SUBJECT: ISSUANCE OF AMENDMENTS FOR DIABLO CANYON NUCLEAR POWER PLANT,
UNIT NO. 1 (TAC NO. M87047) AND UNIT NO. 2 (TAC NO. M87048)

AMENDMENT NO. 90 TO FACILITY OPERATING LICENSE NO. DPR-80

AND AMENDMENT NO. 89 TO FACILITY OPERATING LICENSE NO. DPR-82

SAFETY EVALUATION BY THE OFFICE OF NUCLEAR REACTOR REGULATION
RELATED TO AMENDMENT NO. 90 TO FACILITY OPERATING LICENSE NO. DPR-80
AND AMENDMENT NO. 89 TO FACILITY OPERATING LICENSE NO. DPR-82
PACIFIC GAS AND ELECTRIC COMPANY
DIABLO CANYON NUCLEAR POWER PLANT, UNITS 1 AND 2
DOCKET NOS. 50-275 AND 50-323

FIGURE 5.1-3
MAP DEFINING UNRESTRICTED AREAS AND SITE BOUNDARY
FOR RADIOACTIVE GASEOUS AND LIQUID EFFLUENTS

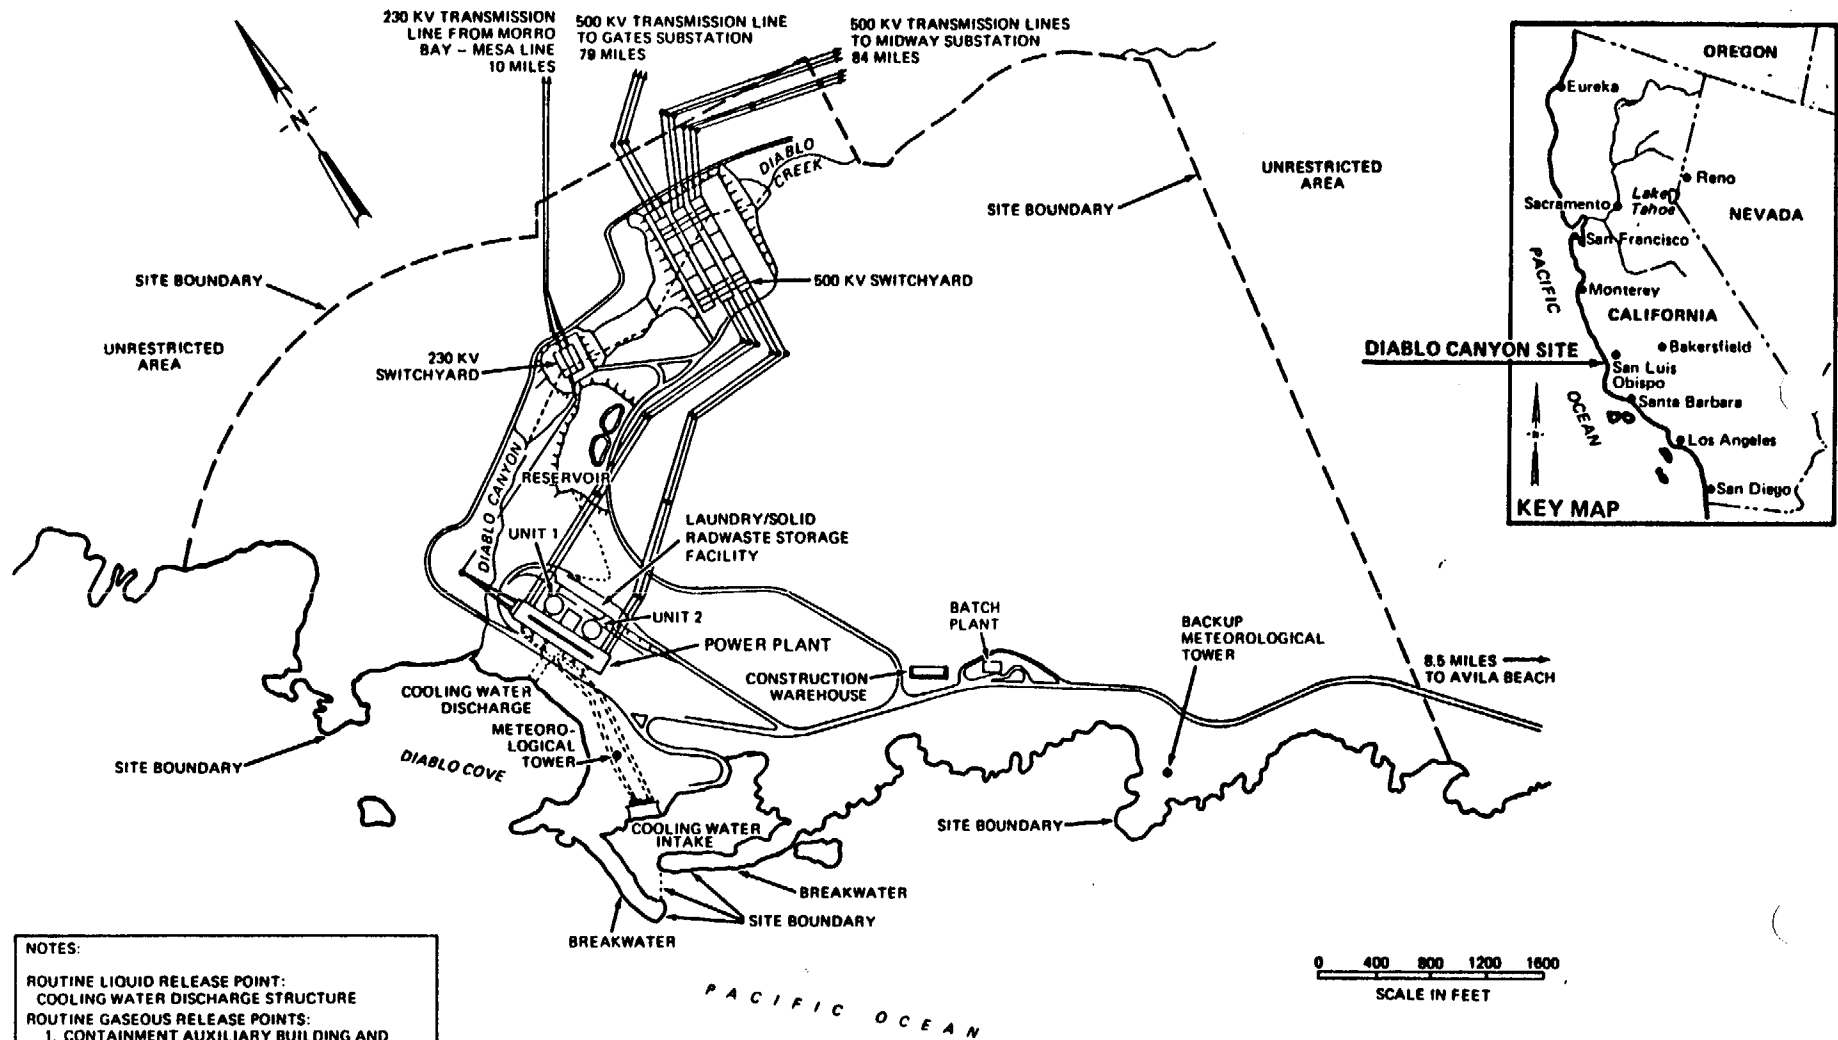
These amendments change the site area map description of the restricted area to be consistent with the revised 10 CFR Part 20, Standards for Protection Against Radiation.

The licensee has proposed to change the site area map description of the restricted area in TS 5.1.3 "Map Defining Unrestricted Areas and Site Boundary for Radioactive Gaseous and Liquid Effluents." The restricted area, which is currently defined as all property within the site boundary is proposed to be changed to a new smaller restricted area.

The licensee has proposed this change in order to limit the number of infrequent visitors that require training concerning radiation, and to allow them to be more appropriately controlled to member-of-the-public dose limits.

The licensee states that environmental monitoring of the area between the unrestricted area and the proposed smaller restricted area has demonstrated that the dose in the area resulting from normal plant operations is well below the member-of-the-public dose limits. Therefore, there appears to be no radiological health protection concern regarding the dose that a member of the public receives in this area.

Additionally, the change to the restricted area will not have a negative impact on the determination of effluent release doses because the effluent release dose rates are based on the site boundary.

The licensee states that the new restricted area will be defined and controlled by plant procedures in accordance with the requirements of the revised 10 CFR Part 20.

Based on the above, the change proposed by the licensee is consistent with the revised 10 CFR Part 20 and is acceptable.
